**PLANNING AND ZONING COMMISSION, REGULAR MEETING  
THURSDAY, JUNE 11, 2026 - 6:00 PM  
COUNCIL CHAMBERS, CITY HALL  
910 S. FRIENDSWOOD DR., FRIENDSWOOD, TX 77546**

**A. PRELIMINARY PLAT: SHERRY LANE PHASE 2 STREET DEDICATION (APPROX. 800 FEET OF ROADWAY)**

**B. PRELIMINARY PLAT: GEORGETOWN BLVD PHASE 2 STREET DEDICATION (APPROX. 1450 FEET OF ROADWAY)**

PRELIMINARY PLAT  
SHERRY LANE PHASE 2  
STREET DEDICATION

**PRELIMINARY PLAT  
SHERRY LANE PHASE 2  
STREET DEDICATION**

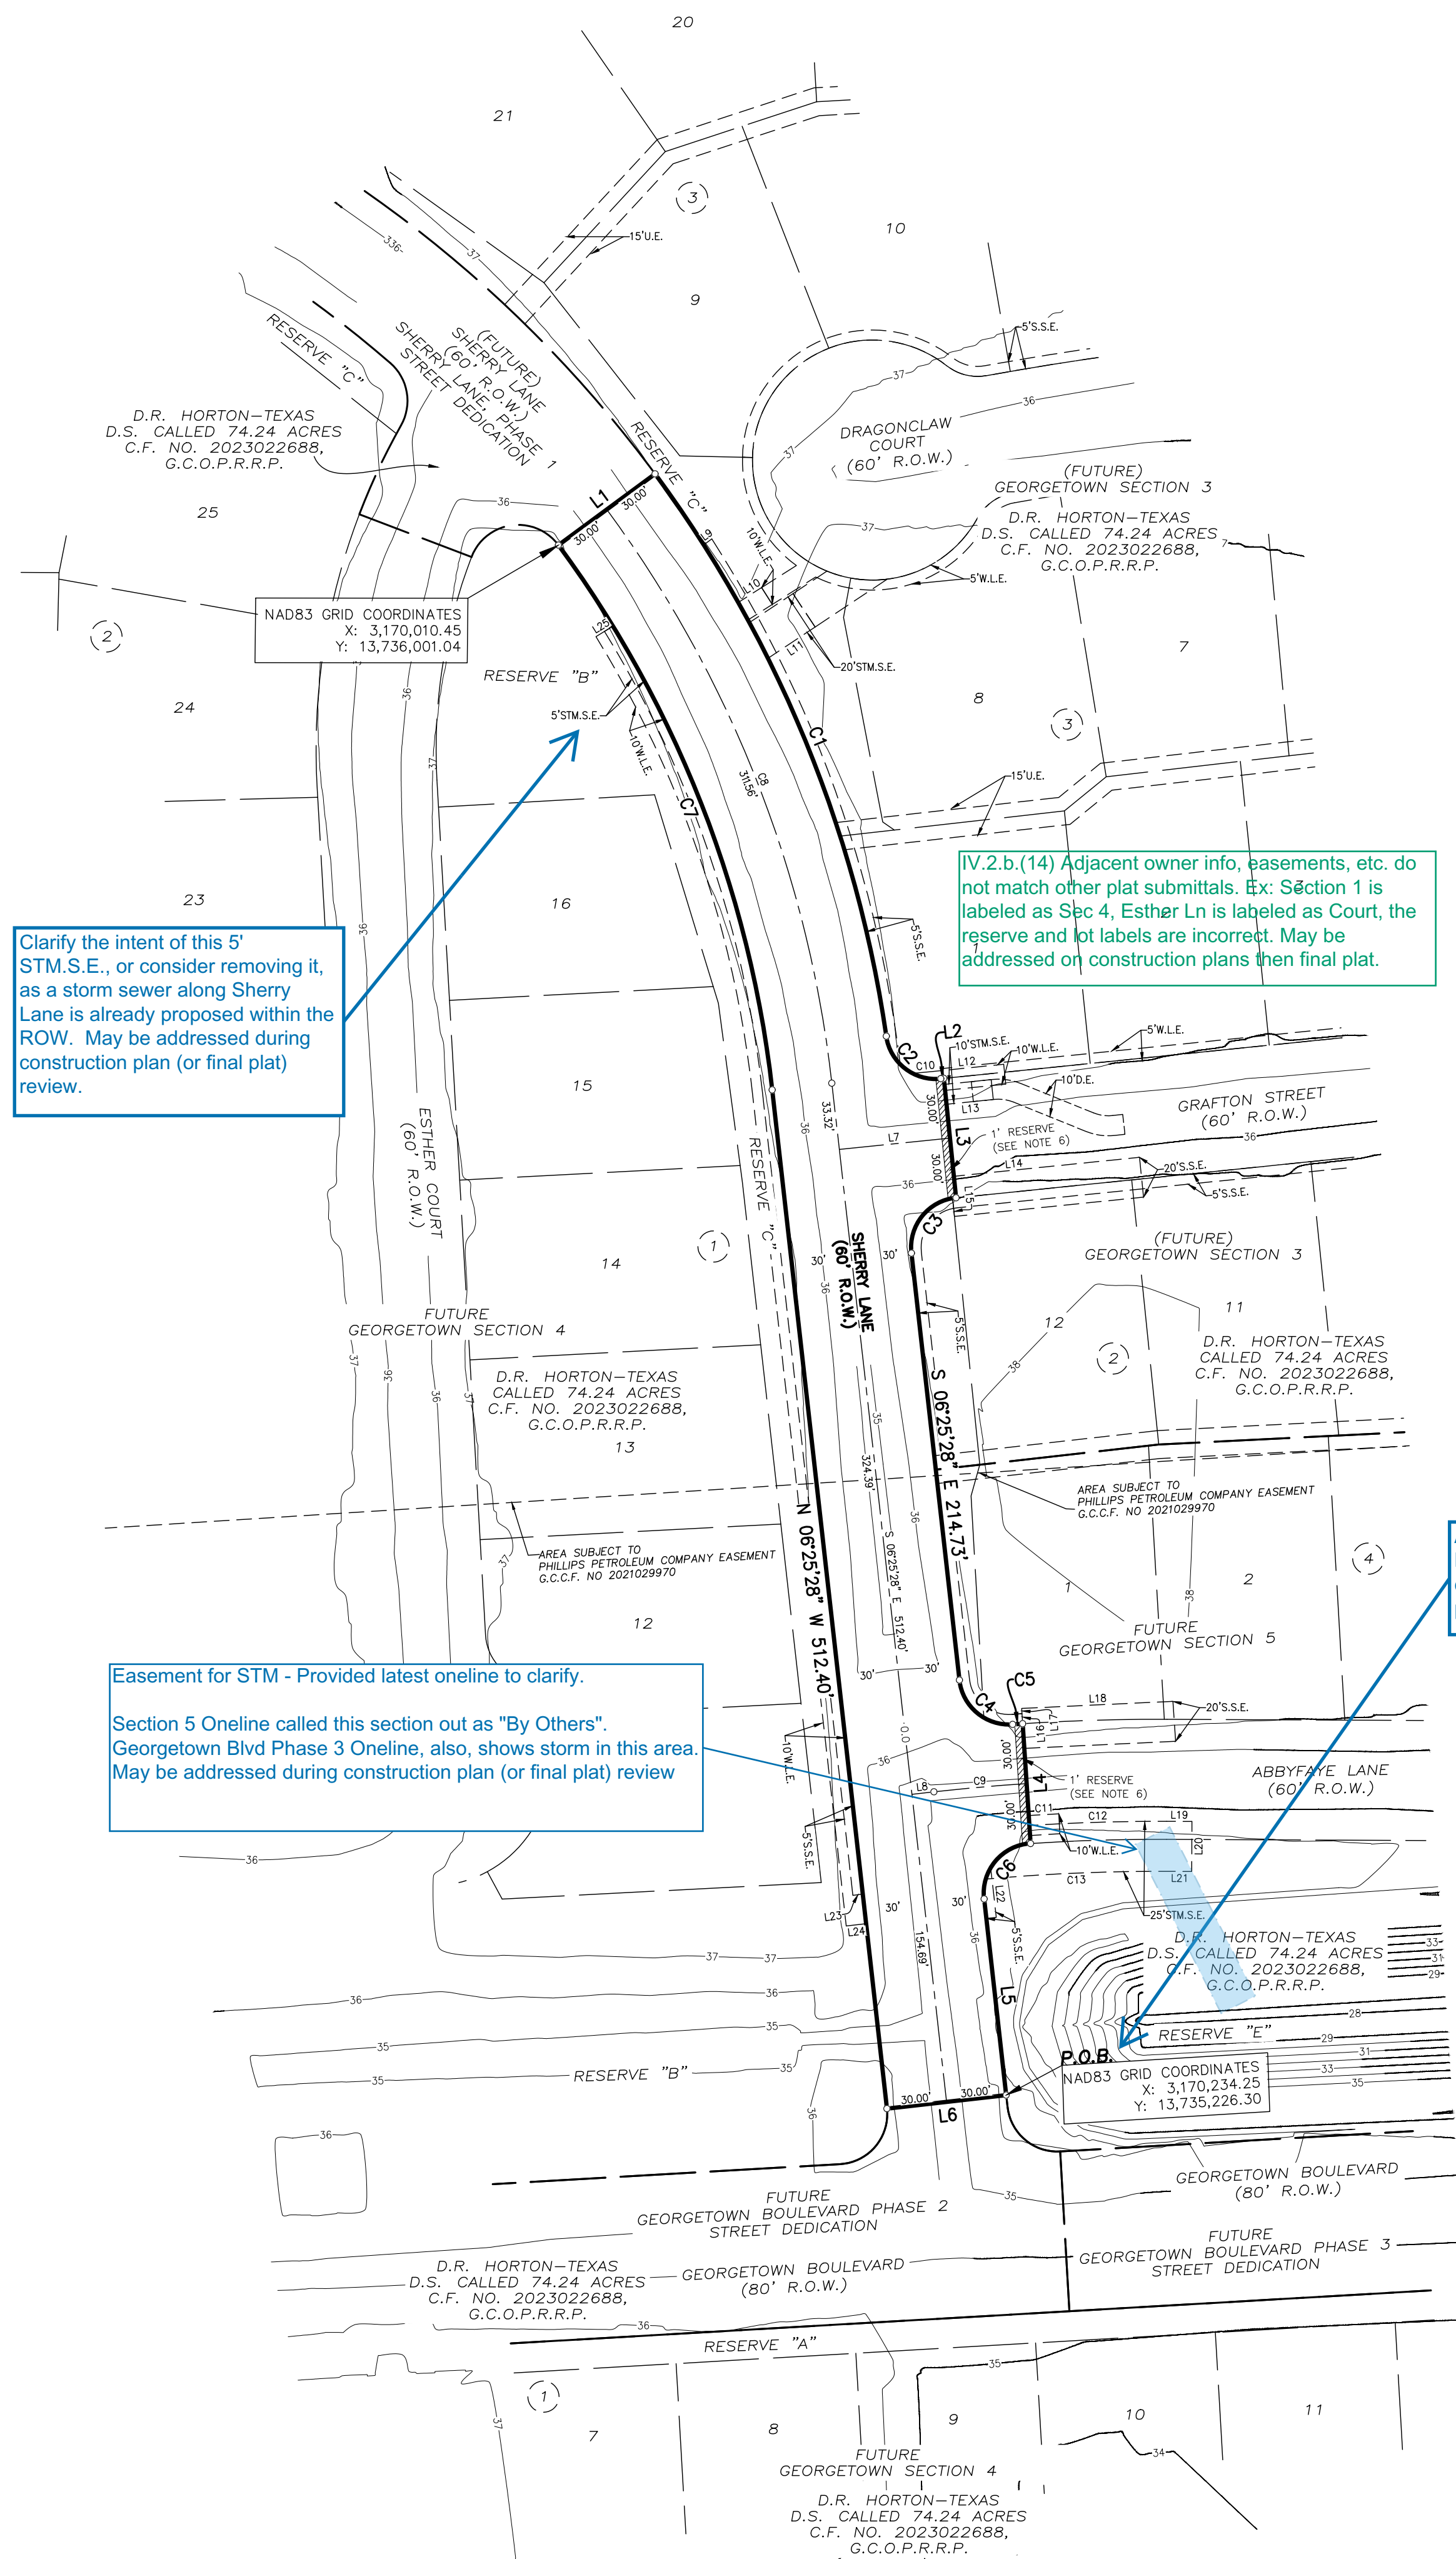
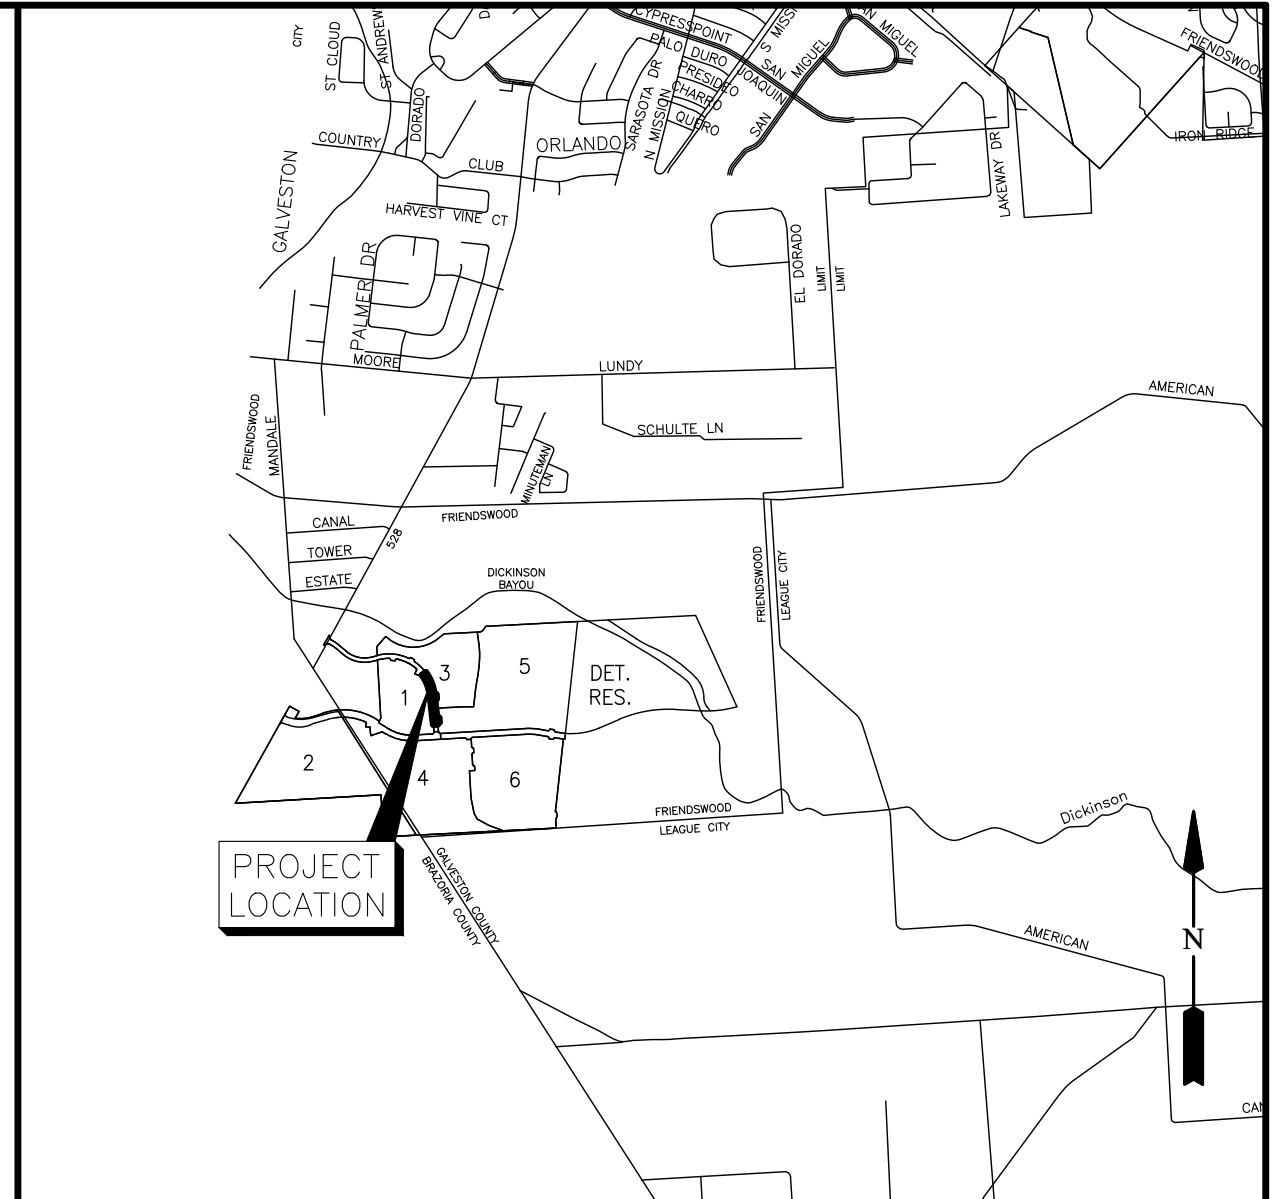
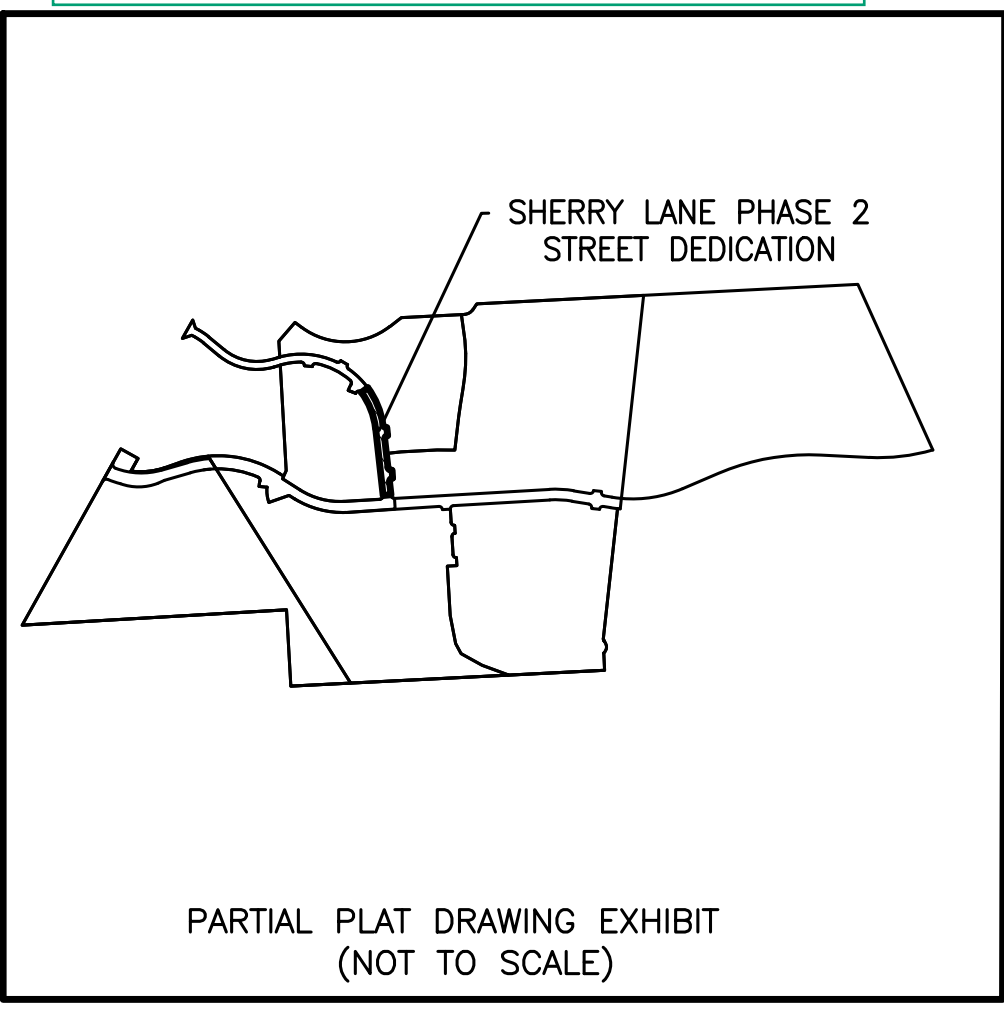
IV.2.b.(1)(a) Correct the plat name. Remove the word Georgetown. May be addressed on final plat.

Information has not been corrected- Key Map & FEMA Map May be addressed during construction plan (or final plat) review

Clarify the intent of this 5' STM.S.E., or consider removing it, as a storm sewer along Sherry Lane is already proposed within the ROW. May be addressed during construction plan (or final plat) review.

IV.2.b.(14) Adjacent owner info, easements, etc. do not match other plat submittals. Ex: Section 1 is labeled as Sec 4, Esther Ln is labeled as Court, the reserve and lot labels are incorrect. May be addressed on construction plans then final plat.

Add acronym to legend. May be addressed during construction plan (or final plat) review.

III.B.4. Partial plat exhibit should identify the parcel/tract being partially platted. Sherry Ln Ph 2 is out of a 132 acre tract per deed #2021029966. Or we would accept out of the current 89.2 ac tract. The property lines shown on the exhibit do not reflect the current configuration of parcels. May be addressed on final plat.

Easement for STM - Provided latest online to clarify. Section 5 Online called this section out as "By Others". Georgetown Blvd Phase 3 Online, also, shows storm in this area. May be addressed during construction plan (or final plat) review.
